PUBLIC SUBMISSION D/2023/113
4-6 BLIGH STREET, SYDNEY

As the land owners of 1 Chifley Square, Sydney, we write to you in relation to the State Significant Development Application lodged at 4-6 Bligh Street, Sydney, which seeks approval for the construction of a 59-storey mixed-use hotel and commercial building with associated basement parking, food and drink premises and business identification signage.

Following a review of the Environmental Impact Statement (EIS) and accompanying documentation, we object to the proposal in its current form as it raises the following concerns:

Figure 4 Indicative building envelope massing (Bligh Street (left) and rear (right))

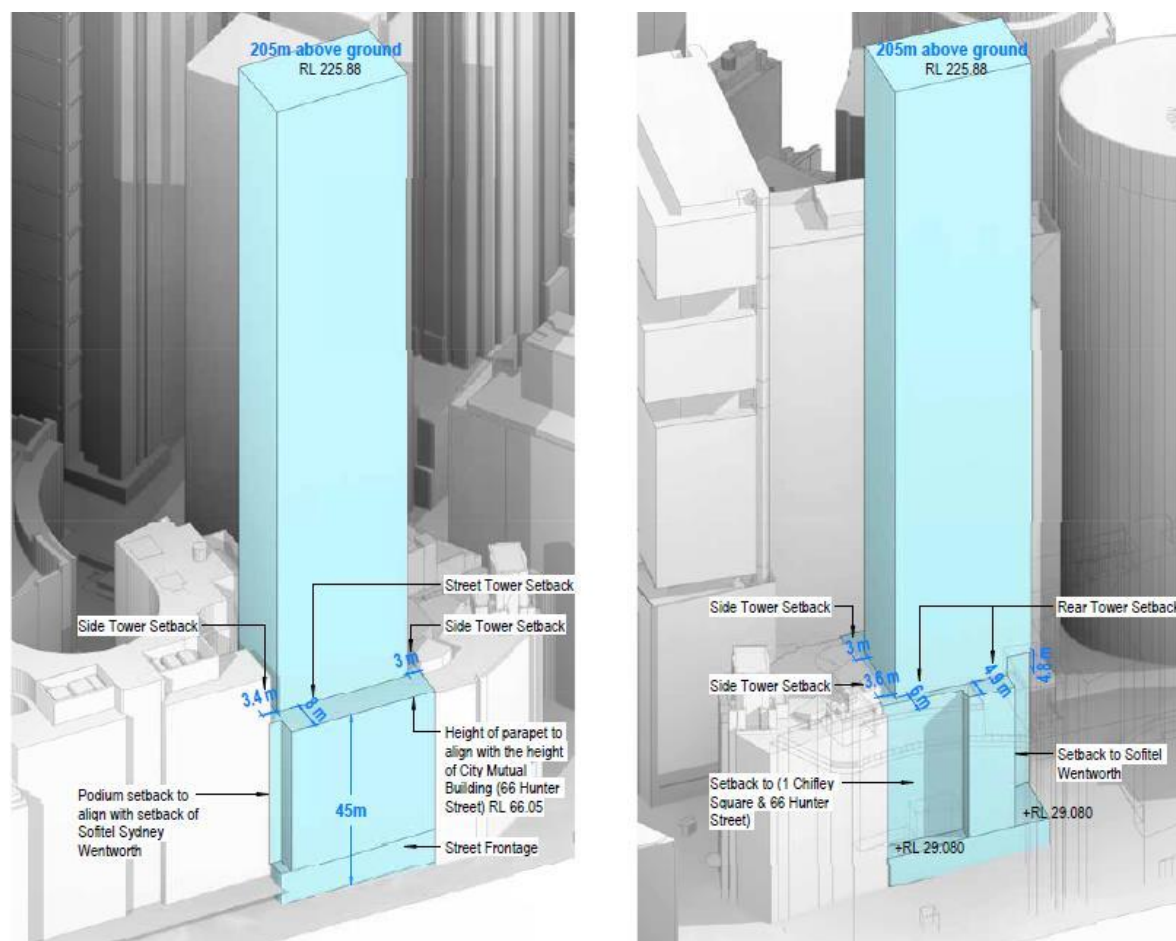
The indicative building envelope massing illustrates a podium RL 29.08, and rear setbacks to 1 Chifley Square (see **Figure 4**).

The rear podium proposes a height of RL 36 adjacent to 1 Chifley Square whereas the site-specific DCP indicated a podium height of RL 29.08 (~7m difference).

Figure 5 Massing study to the rear, adjacent to 1 Chifley Square

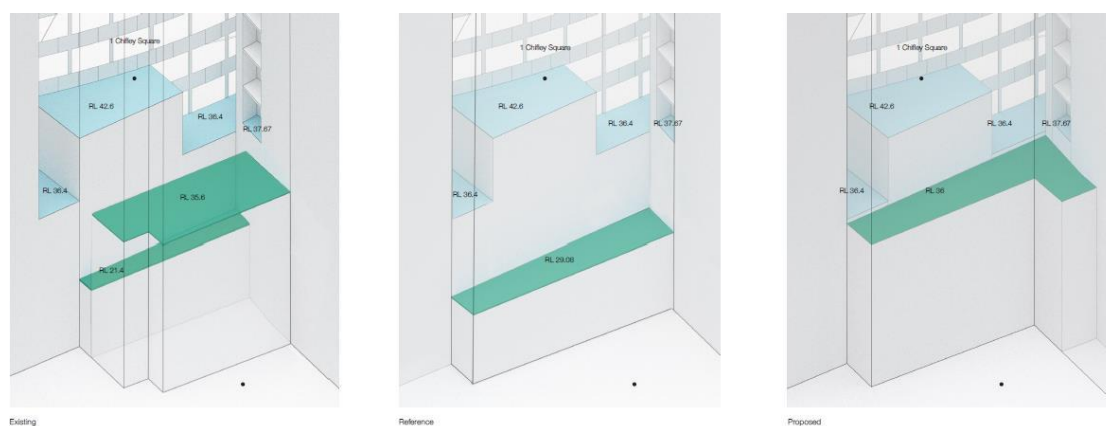
The Proponent has provided massing studies on this relationship to 1 Chifley Square (**Figure 5**), and it is noted that RL 36 relates closely to RL 36.4 at 1 Chifley Square. However, the Proponent has not provided a section diagram illustrating the relationship of the proposal to the existing light well and rear windows of 1 Chifley Square, nor has it provided an analysis of the impact of the additional podium height on daylight access to 1 Chifley Square. It is therefore difficult to assess the impact of the podium height on 1 Chifley Square which is inconsistent with the envisaged built form upon the site under the Sydney DCP 2012.

- The relationship between the vertical garden and podium level is unclear. As per **Figure 5**, the proposed podium height is at RL 36, however, the 'eastern boundary cross section' on page 11 of the Landscape Report illustrates a podium commencing at Level 2 at RL 30.53.
- Page 76 of the Design Report states that the vertical garden runs from Level 3-10, however, the landscape plans illustrate that the landscape garden commences at Level 2.

Figure 6 Requested section

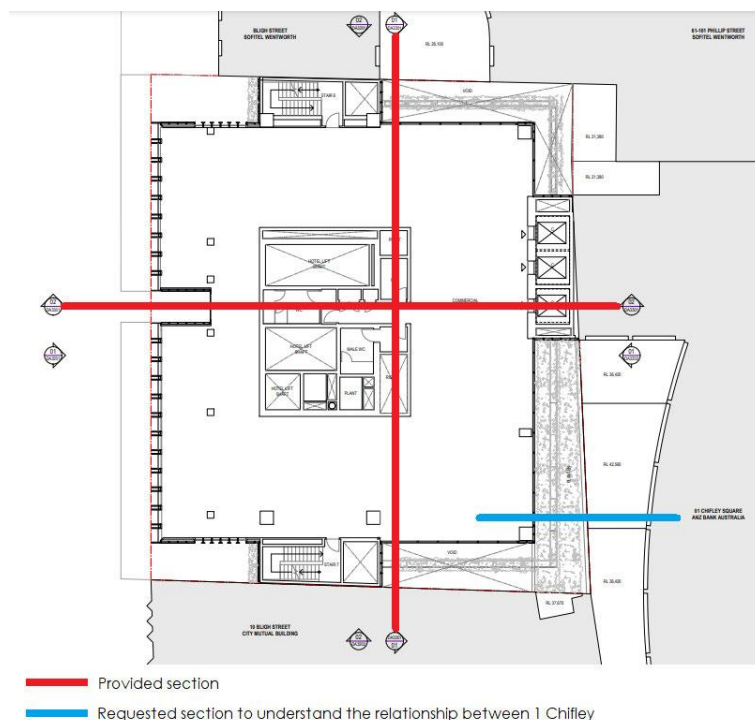
It is requested that a section through the podium and tower is provided in the location illustrated in **Figure 6** to understand the relationship between 1 Chifley Square, illustrating the light well/void, windows, and vertical garden.

Figure 7 Vertical garden setback to 1 Chifley Square

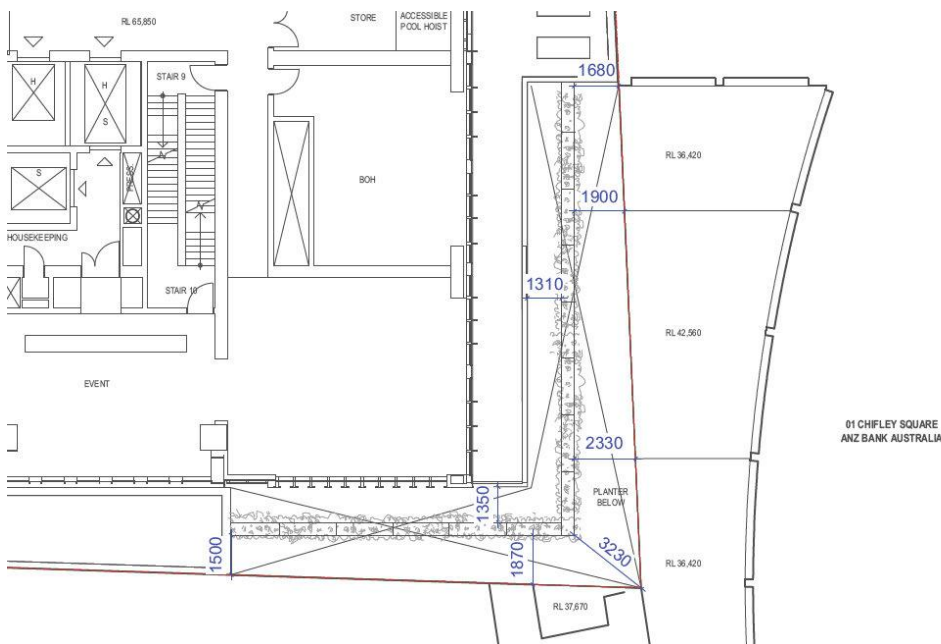
A landscaped vertical garden is proposed on the south-eastern podium elevation from Level 2 to Level 10. The vertical garden sits independently to the podium of the building, and is proposed to be setback 1.68m-2.33m from the shared property boundary (**Figure 7**).

The vertical garden is a substantial structure adjacent to the shared property boundary, which could diminish daylight access to the light well at 1 Chifley Square. The landscaped pergola is proposed to be setback a minimum of 1.68m from the boundary, while the site-specific DCP suggests a 4m setback may be appropriate. On this basis, it is requested that the Proponent undertakes a daylight study to the light well at 1 Chifley Square to understand the impacts of this setback. It is critical to quantify daylight impacts upon our site, and should these impacts be adverse, it is requested that the vertical garden adopts an increased setback, consistent with the Sydney DCP 2012.

Figure 8 Location of Level 2 plant adjacent to 1 Chifley Square

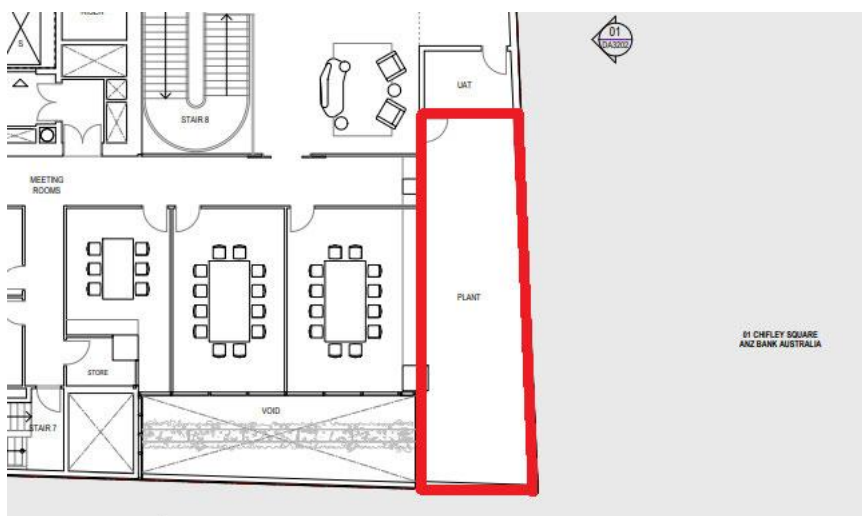
The operational noise emissions from the Level 2 plant have not been considered in the Operational Noise and Vibration Impact Assessment. A preliminary analysis of the mechanical equipment had been conducted to determine the maximum cumulative noise level, and considered the plant rooms in the basement, rooftop, and on Levels 11, 13, 33 and 54 (see section 6.2.1 of the Assessment). However, this Assessment did not consider the impacts of the Level 2 plant which is of concern, given its adjacency to the shared boundary with 1 Chifley Square.

It is requested that this report is updated to consider the cumulative impacts of the development, including noise emissions from the plant room on Level 2.
